## Product Change Notification(PCN)

### IEEE 1394, 6 contacts, vertical version, DIP (2010 catalogue page 137)

Change Notification # : PCN 20131408-A-IEE-DIP

### New version

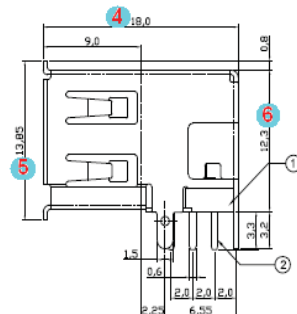
Description of changes: CHANGE OF MANUFACTURING LOCATION  
CHANGE OF ORDERCODE  
1. Amendment of the specification  
2. Tolerance : New : x.xx ±0.13 // x.x ±0.25  
3. Change of dimensions, see sheet 3  
4. Catalogue 2010 shows different specification  
5. Draw.-No. ASS 3559 COrev03 substitutes ASS 3559 COrev02

- (1) 8.4 ±0.30mm
- (2) 11.10 ±0.20mm
- (3) 2.80 ±0.20mm
- (4) 17.8 ±0.30mm
- (5) 13.5 ±0.30mm
- (6) 12.0 ±0.30mm

- (1) 8.7 ±0.25mm
- (2) 11.3 ±0.25mm
- (3) 1.5+1.5 ±0.13mm
- (4) 18.0 ±0.25mm
- (5) 13.85 ±0.13mm
- (6) 12.3 ±0.25mm
